COWART ROAD SUBDIVISION, **RESUBDIVISION OF LOT 2**

APPLICATION NUMBER Holdover DATE September 7, 2006

COWART ROAD PROPERTY SUBDIVISION, RESUBDIVISION OF LOT 2

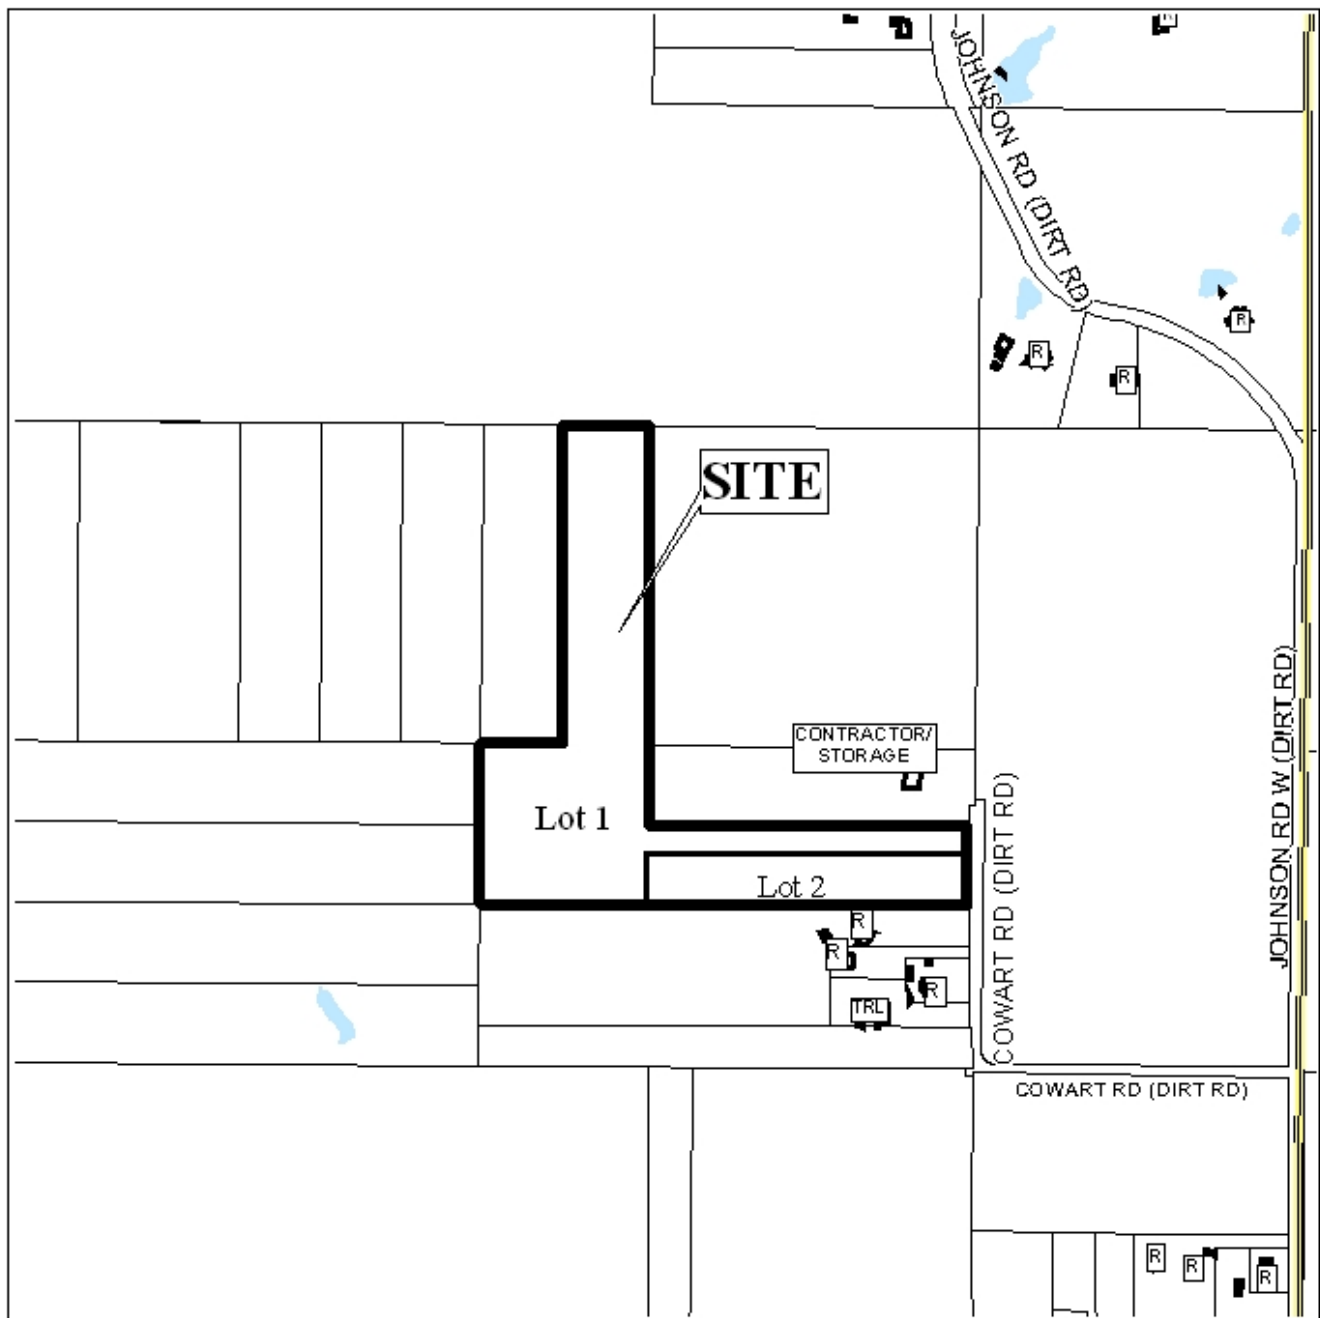
The plat proposes to divide a large, roughly "L"-shaped property with limited street frontage into a narrow rectangular lot, and an irregular lot with a 100-foot wide, 1330'± long appendage providing frontage onto Cowart Road. Given the access concerns for the rear portion of the lot, and the concerns for future development, this is not a desirable configuration. Under normal circumstances, this lot would not be recommended for approval without street construction.

The site is unusual in that it is a lot of record, but the entire parent parcel is not included. There are ten landlocked parcels belonging to the same parent parcel, which was divided without authorization in 1986; five of these were purchased in the 1990s by the applicant, and have since been transferred to a corporation in which the applicant is a member (Mac-Land Inc.). In light of these circumstances, it may be appropriate to allow subdivision of the property in question, but only if all of the Mac-Land-owned properties were included in the application to mitigate the current landlocked situation. While inclusion of properties under other ownership is desirable, it cannot be required, since they have been transferred multiple times without the applicant's involvement. Planning for street construction would also be strongly recommended, to provide access to any remaining landlocked parcels.

because they have access via a recorded 10-foot easement. Such an easement would not satisfy the Subdivision Regulations' requirements that "every lot shall abut a dedicated and maintained public street" (Section V.D.4).

Nevertheless, since the site in question is a lot of record located on a County-maintained street, and the landlocked parcels are held under separate ownership, with certain restrictions, the subdivision may be appropriate. Future Resubdivision of the site should not be allowed without provision of additional access via a dedicated and maintained public street. In addition, the applicant should be aware that the landlocked parcels, which were subdivided without Planning Commission approval after 1984, may not be issued building permits without going through subdivision and without frontage on a dedicated and maintained public street. Because the site is located in Mobile County, a note should be placed on the final plat stating that any lots that are developed commercially and adjoin residentially developed property must provide a buffer, in compliance with Section V.A.7 of the Subdivision Regulations.

Based on the preceding, and with a waiver of Section V.D.1 of the Subdivision Regulations (size and shape of lots), the plat meets the minimum standards and is recommended for Tentative Approval, subject to the following conditions: 1) the placement of a note on the final plat stating that approval from all applicable federal, State, and local agencies will be required prior to the issuance of permits in the floodplain; 2) the placement of a note on the final plat stating that there will be no future Resubdivision of the site until additional access is provided via a dedicated and maintained public street; and 3) the placement of a note on the final plat stating that any lots that are developed commercially and adjoin residentially developed property must provide a buffer, in compliance with Section V.A.7 of the Subdivision Regulations.
